FINAL PLAT

AUBURN HILLS ADDITION

Re: S/D 94-12 - AUBURN HILLS ADDITION (Final Plat)

CASE NUMBER: S/D 94-12 AUBURN HILLS [Previously CANNONBALL ADDITION (135th & Maple)]

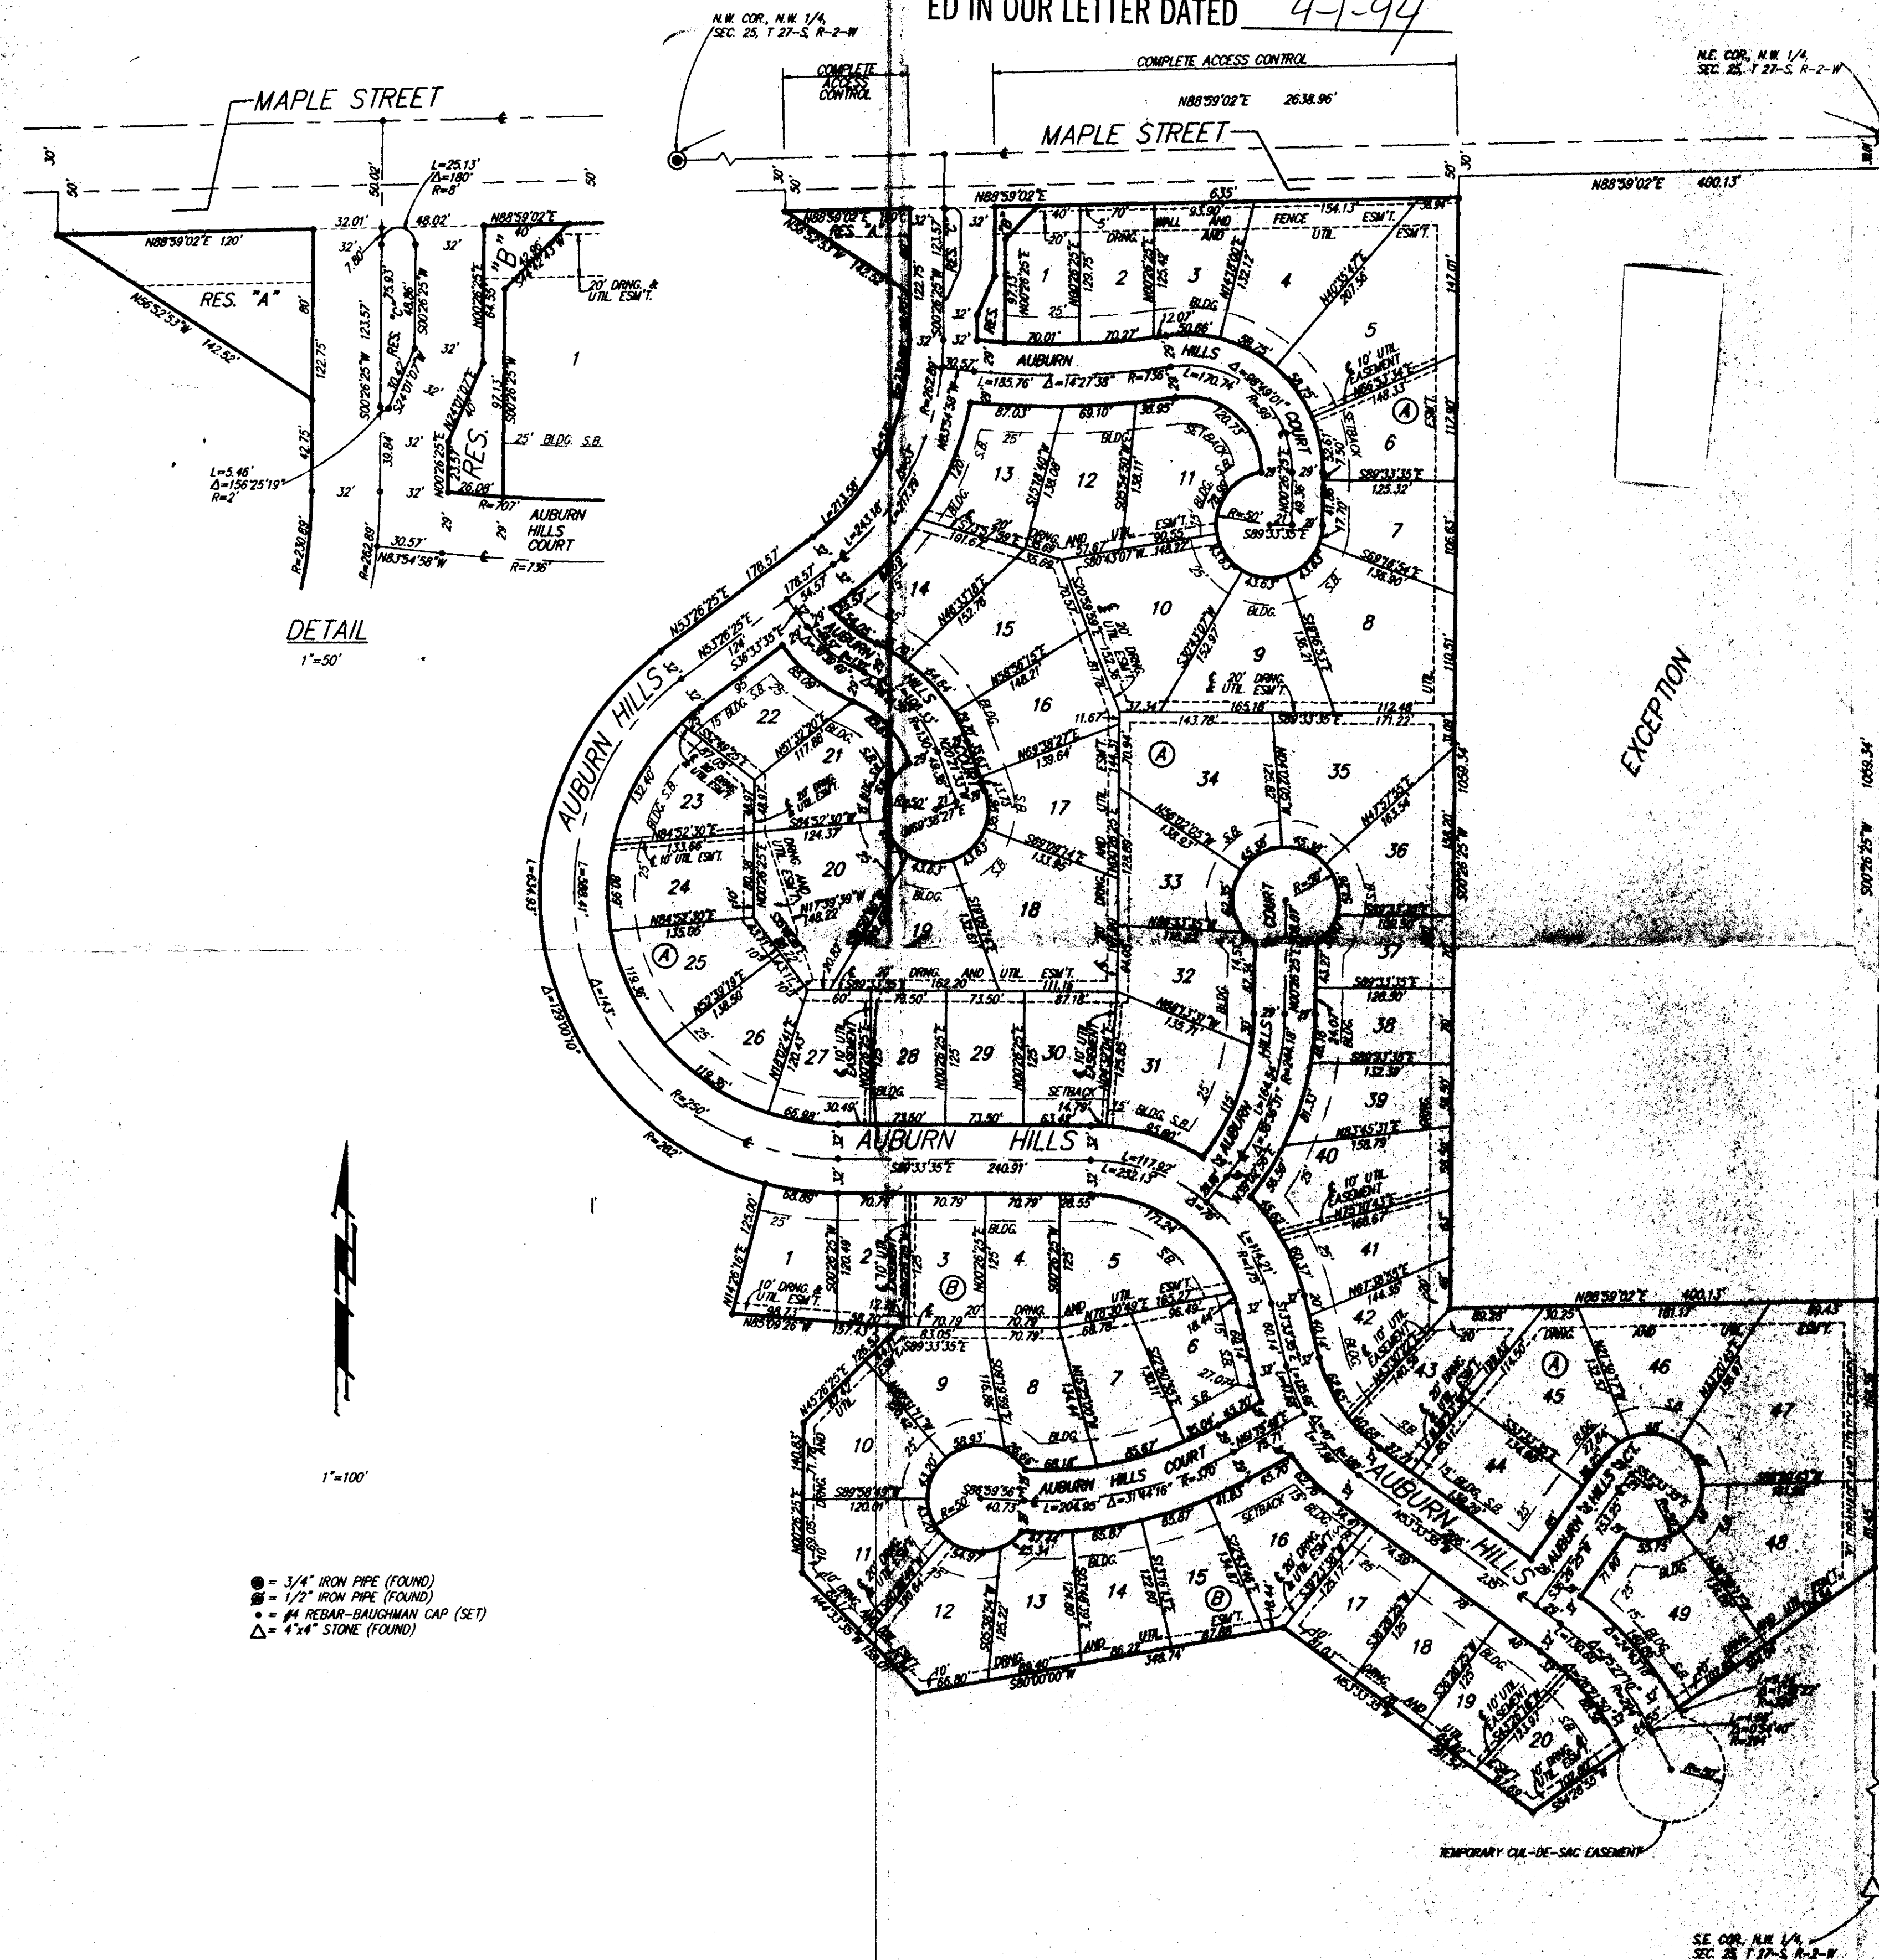
- T. Recording of the plat within 30 days after approval by the City Council.**
- U. As requested by City Engineering, the applicant shall submit, by separate instrument, needed off-site drainage and utility easements. These easements need to be submitted to Engineering for review and approval and subsequently to Planning with the plat, for recording.**

Also, as indicated by City Engineering, minimum building pad elevations shall be dedicated for all lots adjacent to an open space area containing lakes and/or detention ponds. It shall be noted if the elevation is for the lowest opening or floor elevation and both on-site and off-site benchmarks shall be referenced.

- A. Prior to this plat being scheduled for City Council review, this site will need to be annexed to the City. Annexation is required in order to plat the size of lots being indicated by this plat. Although this portion of the quarter section does abut the present City Limits at its eastern most property line and can therefore be annexed by itself, it is recommended that the applicant(s) submit an annexation request for the entire quarter section.

- B. The applicant shall guarantee the extension of sanitary sewer to serve the lots being platted.
- C. The applicant shall guarantee the extension of City water to serve the lots being platted.

- D. The applicant shall guarantee any drainage improvements required by the platting of this property.
- E. The applicant shall guarantee construction of the storm sewers required by this plat.

- F. The applicant shall guarantee the paving of the proposed interior streets.
- G. The above paving petition shall also provide for sidewalks along one side of Auburn Hills. Based upon the overall sketch plat, some portions of sidewalks could be considered, as an alternative, being located in an open space/drainage corridor that crosses this site from west to east. At this time the applicant shall guarantee sidewalk adjacent to the street up to the vicinity of Lot 1, Block B. Based upon the applicant's overall plans for this area and indicated agreement, an equivalent segment of sidewalk may be placed in the open space reserve to be platted south of this site rather than along the remaining portion of Auburn Hills.

- H. In terms of the overall development planned for this quarter section, 135th Street West can be expected to be a major means of access to both the residential development and if a 16 acre area of "LC" zoning is obtained, even more so for these uses. As an unpaved street consequently, paving is going to be needed for this street south from Maple. This plat and all subsequent plats in this quarter section need to therefore guarantee their participation in future paving of 135th Street that is proportionate to the traffic impact created by this development.

Therefore, before submitting the final plat tracing for City Council review, the applicant shall meet with Planning and City Engineering in order to determine an appropriate guarantee from this site for the paving of 135th Street West.

- I. The overall plan for this site is indicating that approximately 370 single family lots will be

developed. Only one entrance, as shown on this plat, and two off of 135th Street West will be used for access. These improvements need to be considered not only in light of the anticipated number of residential lots but also the potential "LC" zoning being proposed. As indicated by Traffic Engineering, a guarantee shall be provided for left-turn improvements in Maple to serve this site's entrance at Maple. This guarantee will be held until traffic levels and planned improvements to Maple warrant this improvement.

- J. Provisions shall be made for ownership and maintenance of the proposed reserves. The applicant shall either form a lot owners' association prior to recording the plat or shall submit a covenant stating when the association will be formed, when the reserves will be deeded to the association and who is to own and maintain the reserves prior to the association taking over those responsibilities. This covenant shall provide that the homeowners' association will maintain the open space area or "parking strip" located between this plat's north line and the paved surface of Maple.

- K. The applicant shall submit a covenant which provides for four (4) off-street parking spaces per dwelling unit on each lot which abuts a 58-foot street. The covenant shall inventory the affected lots by lot and block number and shall state that the covenant runs with the land and is binding on future owners and assigns.

- L. As requested by the representative from the City's Fire Department, the street names on this plat shall be changed to reflect the use of the existing street name Limuel.

- M. The platting binder presently indicates that this site is owned by another party or not as is indicated on this final plat. Before the plat will be released for recording, proof of ownership shall be shown for the party indicated on the final plat.

- O. The applicant's engineer is advised that the Register of Deeds is requiring the name(s) of the notary public, who acknowledges the signatures on this plat, to be printed beneath the notary's signature.

- R. The applicant needs to determine with Engineering the nature or extent of any detailed drainage study needed for the overall quarter section in which this plat is located.

- S. Perimeter closure computations shall be submitted with the final plat tracing. Section
